**RE: Response to comments on the 3 October 2023 technical memorandum titled “Modelling of drawdown impacts from proposed rig supply bores in the Bennett Resources Valhalla Gas Development Project”**

**Re:** Revised modelling of drawdown impacts from proposed rig supply bores in the Bennett Resources Valhalla Gas Development Project

Figure 5-1. Mod 1 model results presented as drawdown contours after 6 months of pumping with contour interval = 0.2 meter.

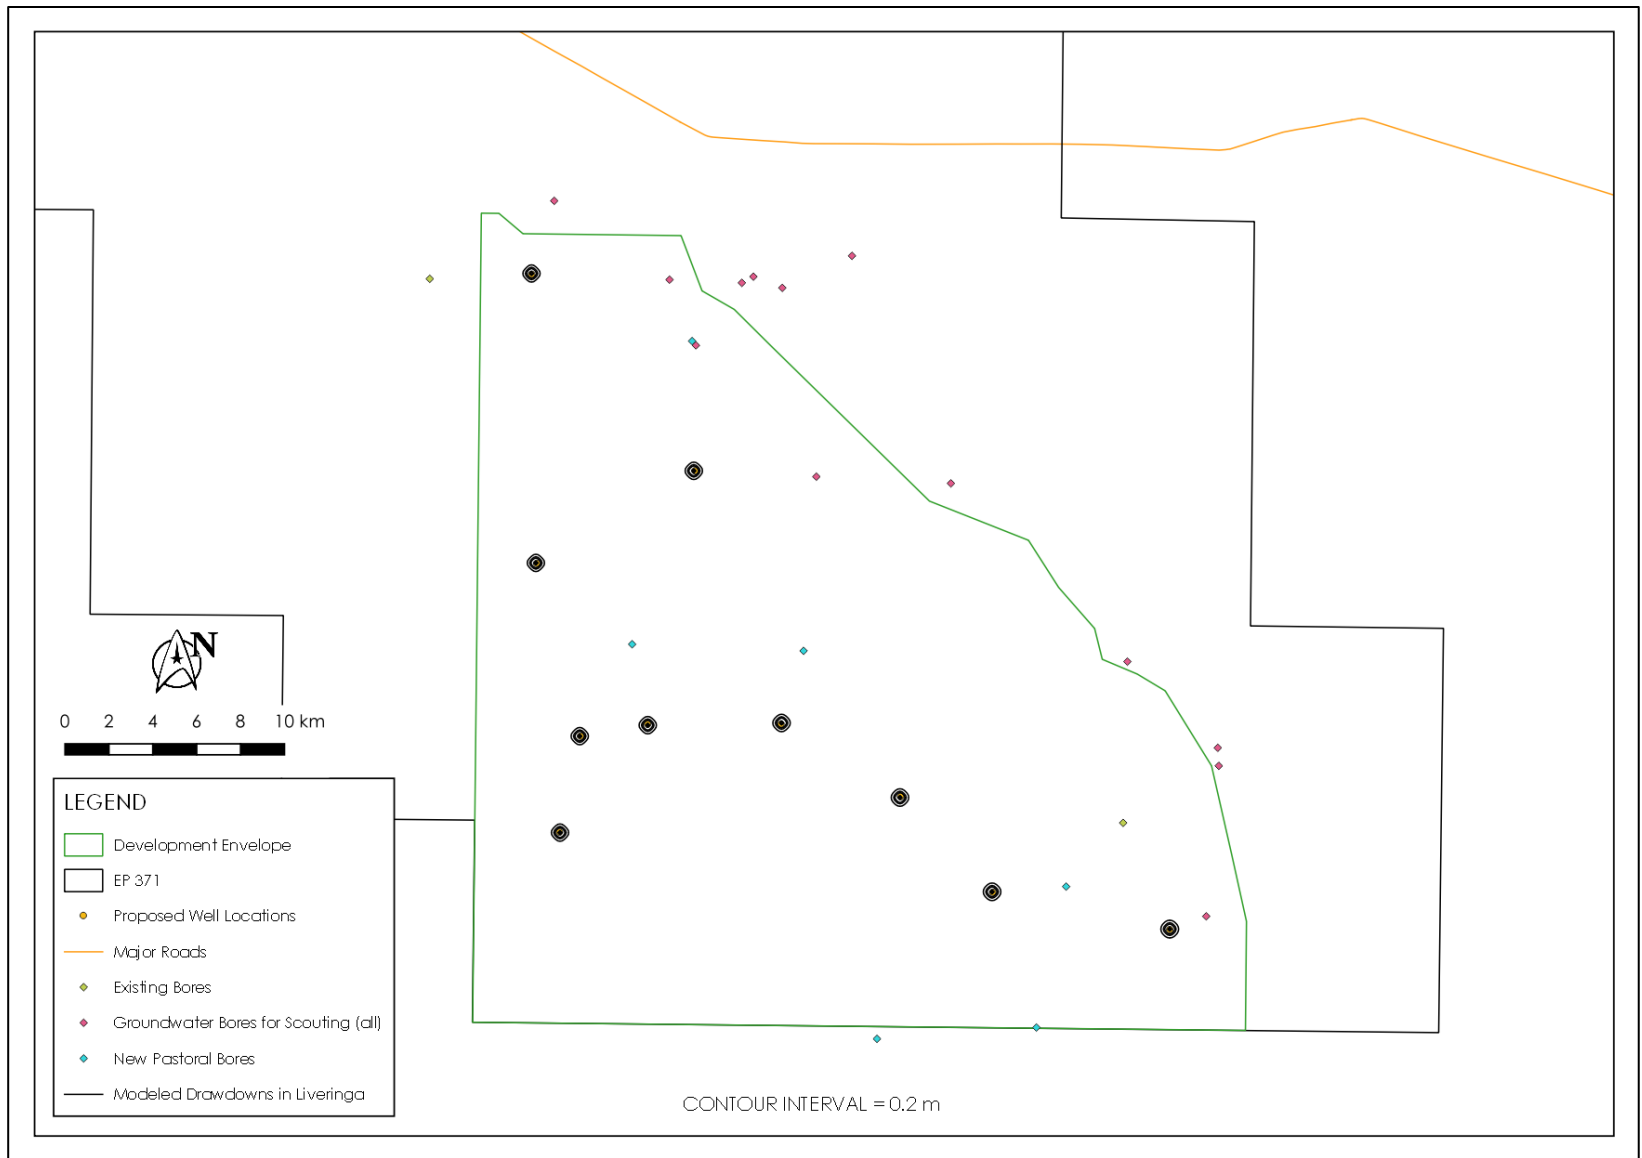
1. *The model has several parameter assumptions and many limitations.*
  - a. *Can the parameters and assumptions be clearly stated. Specifically, can a sensitivity analysis be conducted for these parameters [aquifer/aquitard thickness, hydraulic conductivity, aquifer thickness, storage] (i.e. increase/decrease the values and run multiple options through the model to understand the impact of these assumptions)*

In response to this comment, the model developed for the original memo was ported to the MODFLOW 6 software environment and the original models simulations were performed. Updated drawdown maps and a discussion of the results are presented in Section 5 of the revised memo. In summary, all model results are essentially equivalent to the previous results. For the Liveringa simulation the modeled drawdowns at all existing bores were less than  $<0.01$  m and the production wells were capable of producing the required amounts with drawdowns that are much less than the available saturated thickness. For the Grant/Poole simulation, the modeled drawdowns at all existing bores were less than 0.4 m and the production wells experienced drawdowns of less than a meter.

**Figure 5-1** shows modeled drawdowns at the end of the 6-month pumping period for Mod 1. Modeled drawdowns at the pumping bores range from 7.3 m to just under 8 m. The radius of the 0.2-m drawdown contour for each bore is within 500 m of each pumping bore. All 0.2-m drawdown contours are greater than a kilometer from any existing bores in the project area. Mod 1 indicates that production of the required volumes of water should not result in any observable impacts to existing bores.
